**CITY OF TEMPE
DEVELOPMENT REVIEW COMMISSION**

**Meeting Date: 01/14/2020
Agenda Item: 10**

ACTION: Request a Use Permit Standard for side yard reduction from 10’ to 8’ and a Development Plan Review for four new single-story single-family homes for 19TH STREET RESIDENCES located at 667 West 19th Street. The applicant is Habitat for Humanity.

LANDSCAPE PLAN
HABITAT FOR HUMANITY
 TEMPE, AZ 85281
 CENTRAL ARIZONA
 9133 NW GRAND AVE
 PHOENIX, AZ 85045
 O: 623.583.2417
 ROC 251891

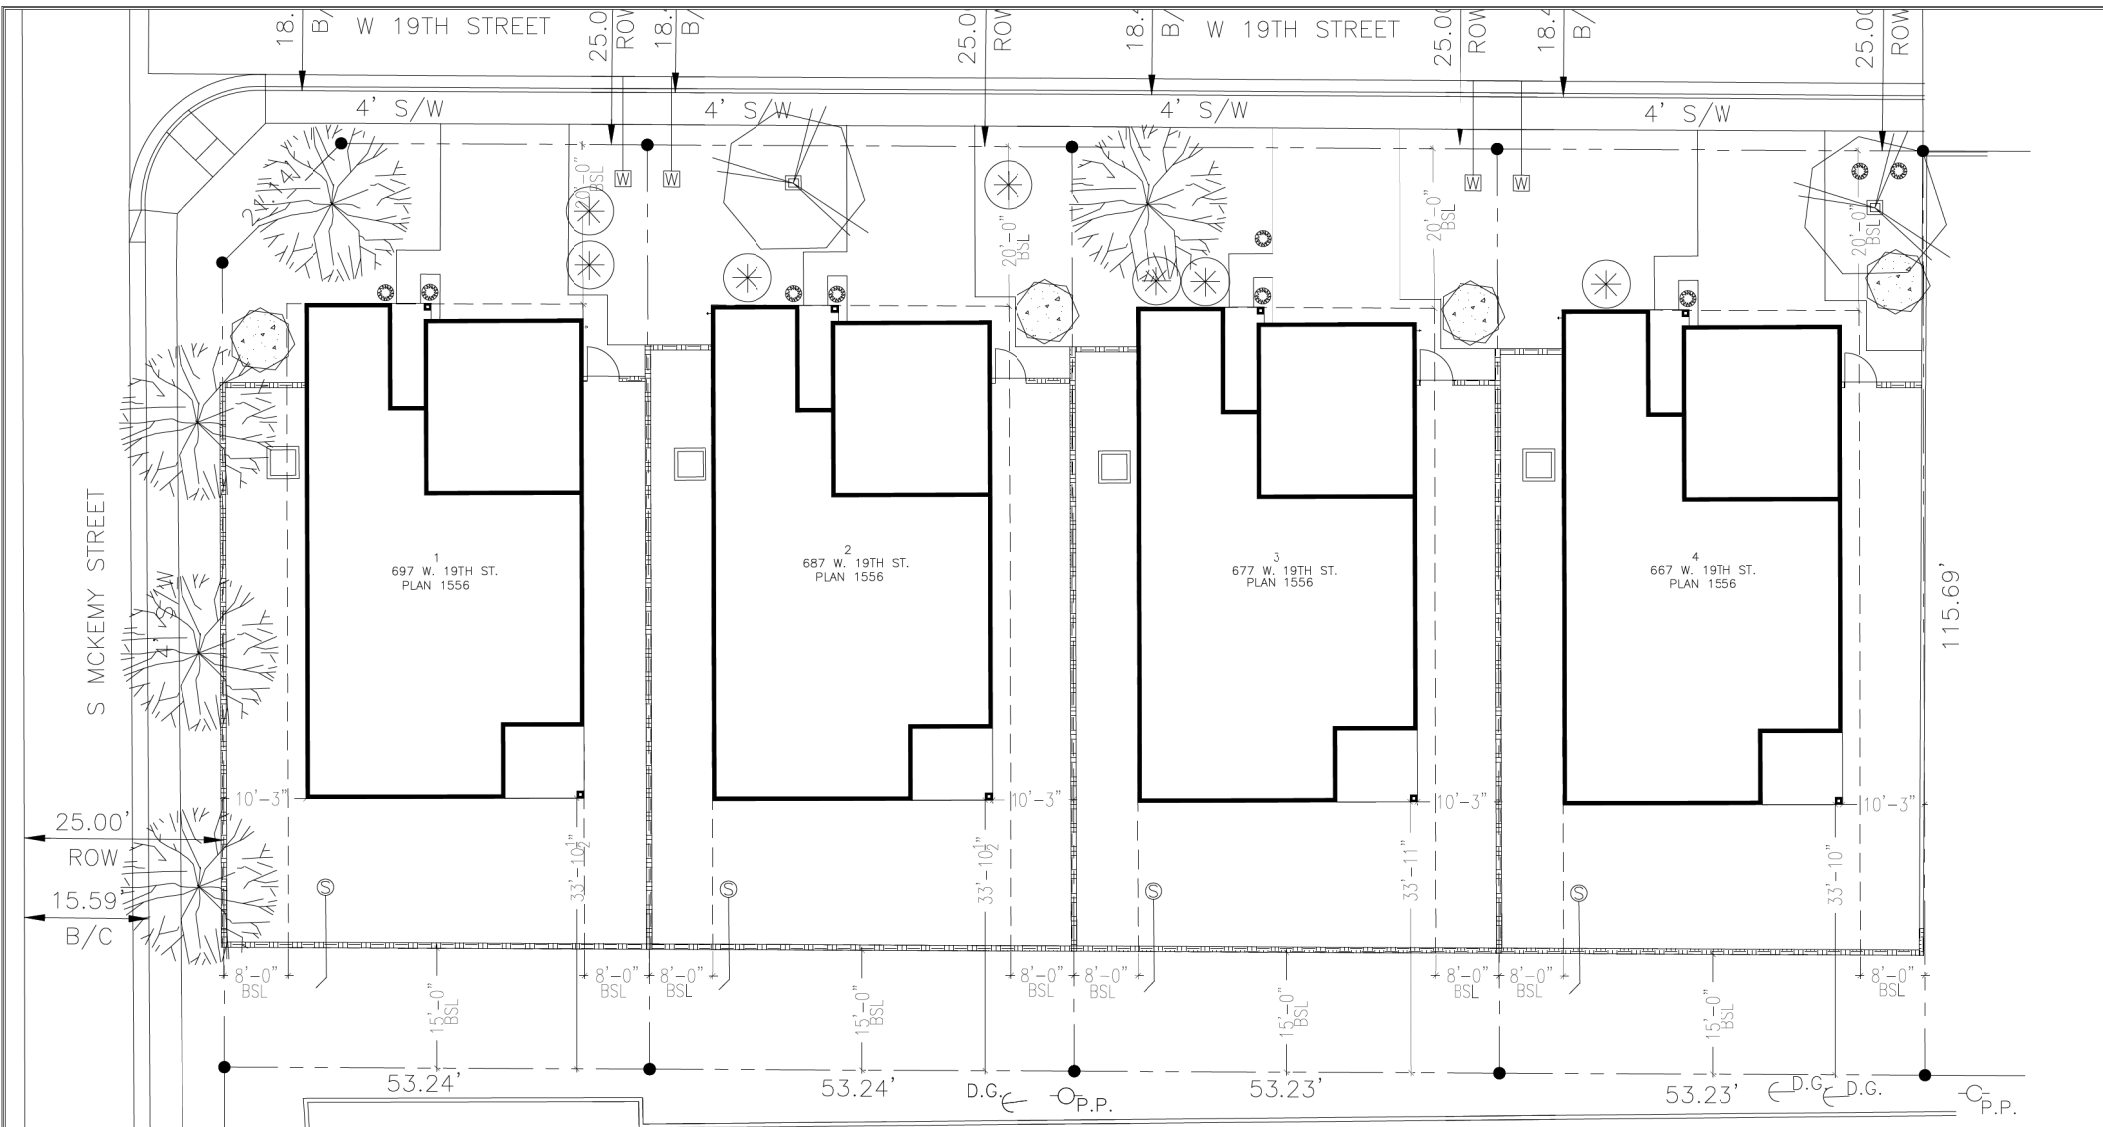
6. Although the color elevations showed lush plants at the base of the building, the landscape plan did not include these plants or meet design standards for front yards. Trees are only 10.5 gallon and yards are predominantly gravel. Staff has conditioned the landscape plan to include 1 ½" caliper trees and a palette option for a mix of ground cover and shrubs to provide more vegetative ground cover.

8. Recommendations were made for the planting plan, but the landscape plans did not provide sufficient plant variety or quantity to meet design criteria.

The landscape plan provides residents with a choice of two trees, either Thornless Mesquite or Palo Verde, the plan has a choice of two shrubs, Cassia or Sage, and one ground cover, Red Yucca. Staff has conditioned the proposed planting plan to provide more biodiversity and more vegetative ground cover.

8. Each lot owner shall be given the choice of four of any of the following combinations of 3-5' shrubs: Silver Cassia, Texas Sage, Tecoma stans 'sparky', Ruellia peninsularis, Bougainvillea, Mexican Bird of Paradise, Eremophila valentine and/or Hop bush.

9. Each lot owner shall be given the choice of seven of any of the following combinations of 2'-3' ground covers: Red Yucca, Eremophila glabra, Muhlenbergia, Rosemary, Gold Lantana, Bush Morning Glory, Acacia redolens.

10. The McKemy Street side yard shall have three street trees of one of the following species, per the owner's selection: either Evergreen Elm, Chinese Pistache or Heritage Oak, and shall be a minimum of 1 ½" caliper.

11. The McKemy Street side yard shall have three shrubs from the 3-5' plant list of the owner's choice, spaced between the trees along the west side of the wall and three ground covers from the 2' plant list planted at the corner of the lot at the intersection of the streets adjacent to the sidewalk; these six plants are located within the right of way and are in addition to the front yard landscape.

FLOOR PLAN
ELEVATION A 3/16" = 1'-0"

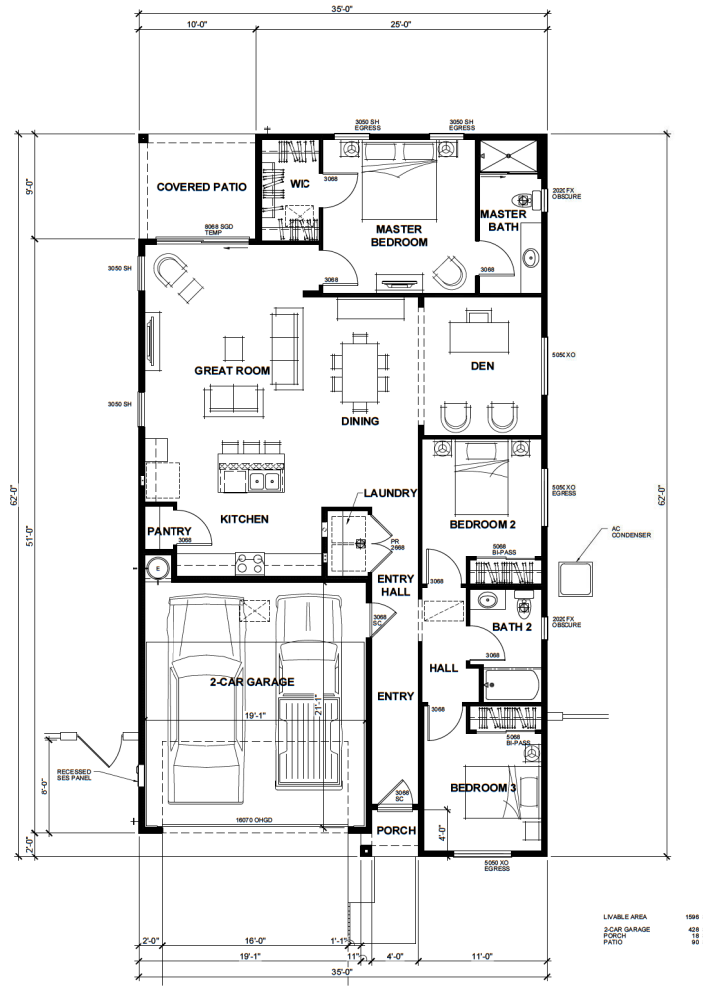
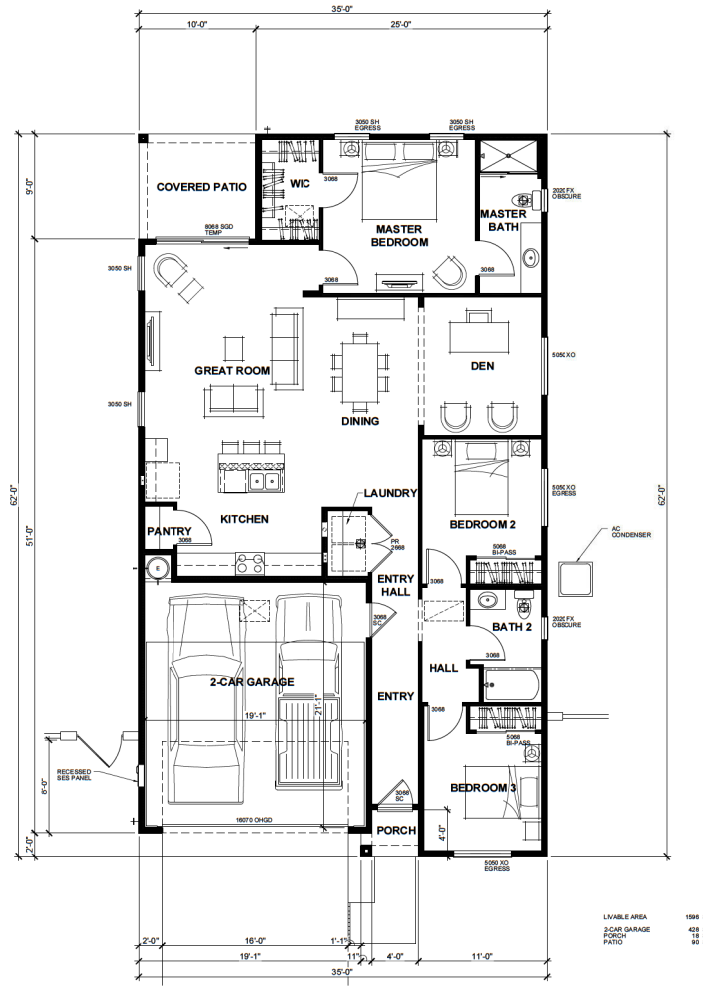
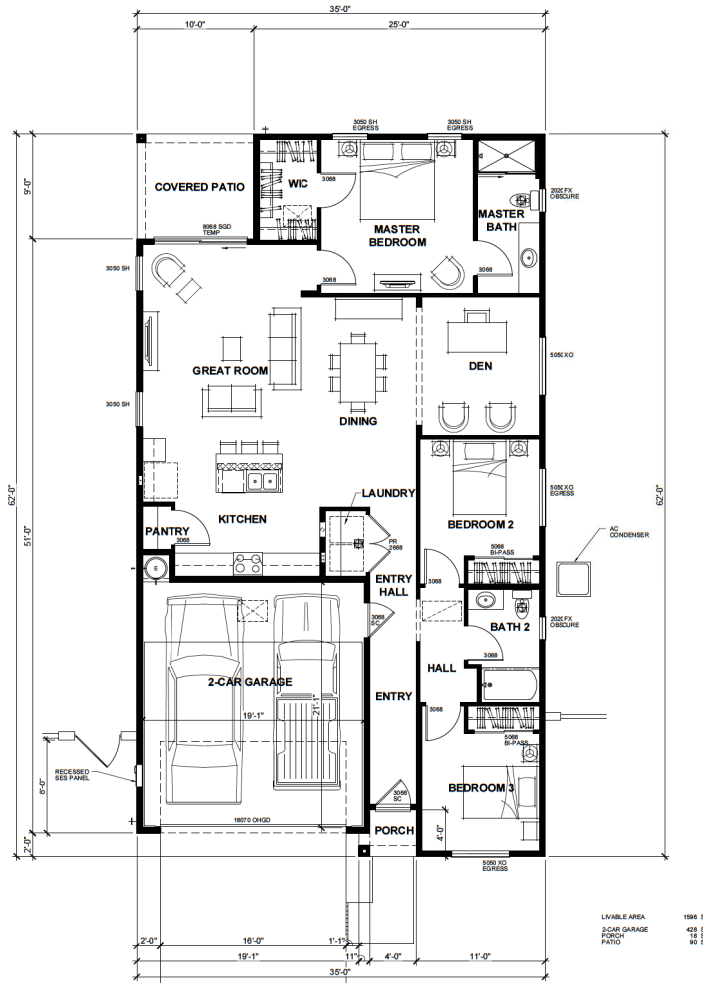
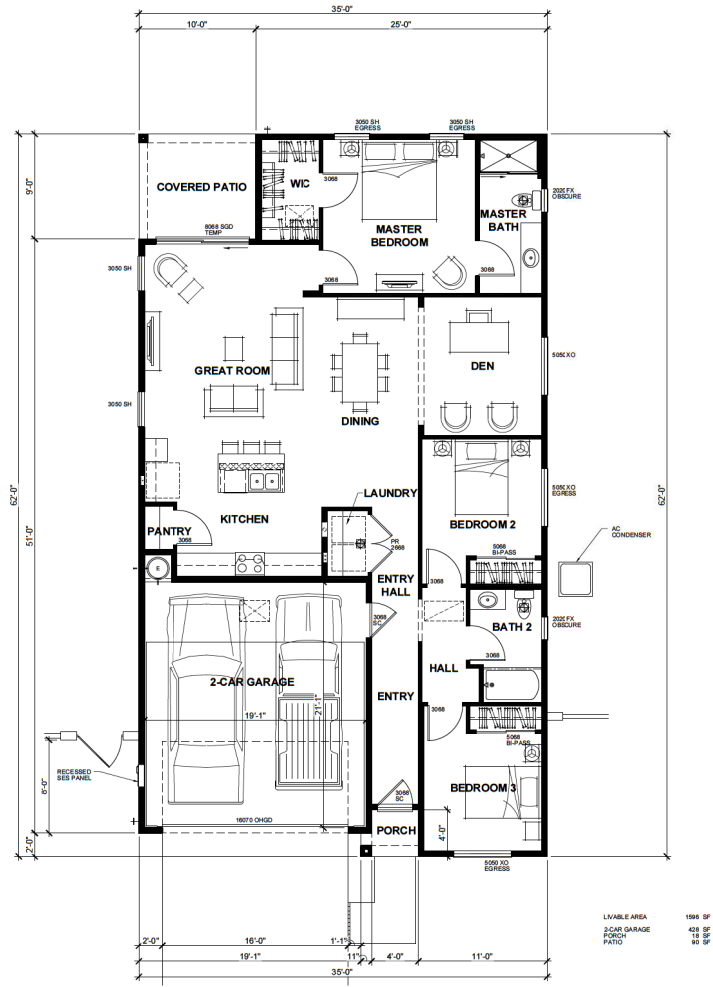
5. The garage was recommended to be a min. of 20' x 20' to provide sufficient room for full size vehicle circulation, the applicant dimensioned the interior, it is 21' long by 19'1" wide. The plan could be enlarged by 11". However, the applicant did not to make the change; they did not want to modify the proposed concrete foundation and truss design to comply. A condition was added to respond to the garage width accept 19' for these four homes. The Use Permit Standard allows sufficient room to shift the units and provide a full-size garage.

3. Garage: Interior dimensions of garage shall be 20' x 20', or no less than 19' in width, to provide sufficient room for parking of 2 full-size vehicles and pedestrian circulation for egress.
